Service Information Letter

Title: Software Upgrade digital ASI and ALTI		
AG-SIL-2018-01-B-EN		Compliance Category:
Applicability		A – MANDATORY B – RECOMMENDED C – OPTIONAL
Aircraft type & model: Any AutoGyro type, fitted with digital ASI (Software Version 2.16 and older) and ALTI (Software Version 2.12 and older)	Betroffene Werknummern: Any AutoGyro type, fitted with digital ASI (Software Version 2.16 and older) and ALTI (Software Version 2.12 and older)	
The maintenance manual to be referenced is this stated or subsequent issue.		As per AutoGyro website
This form is the response from AutoGyro GmbH either against a problem found in the product in service requiring a containment or rectification action, or as service information for aircraft modification incorporation. For help, contact AutoGyro on 49(0)5121 88056-00, or email airworthiness@auto-gyro.com .

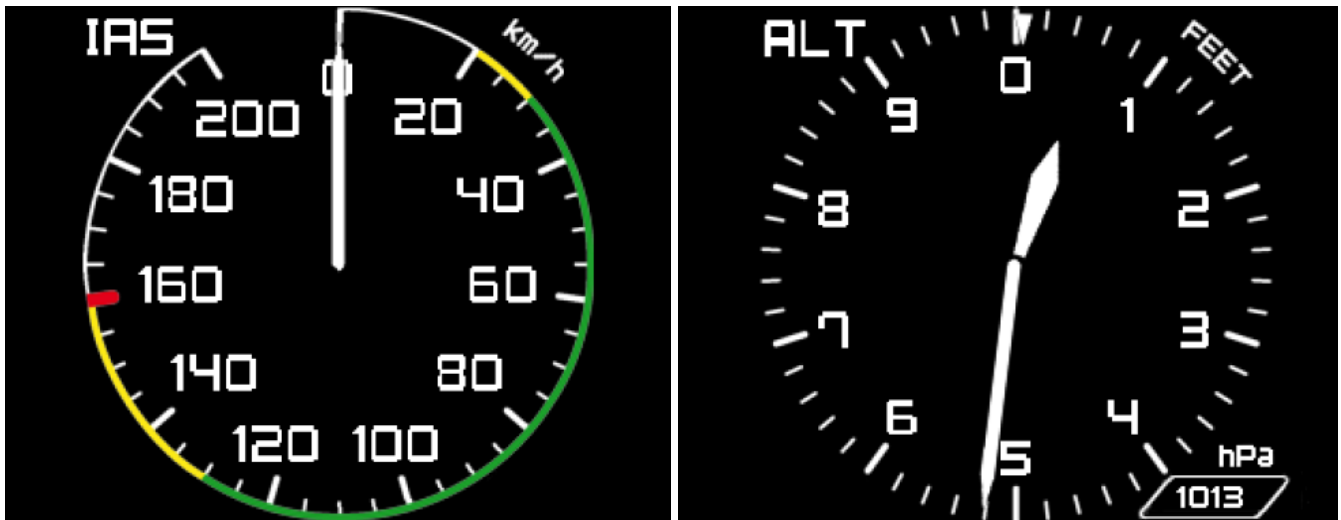
AutoGyro has listened to market feedback regarding the visual appearance of instrument displays, and of the device reliability. The company decided to offer an upgrade to owners that makes the devices easier to read in different lighting conditions, and improves the operational reliability. Any device with a display as shown below may be upgraded to software level 2.17.

Original instrument display

New instrument display
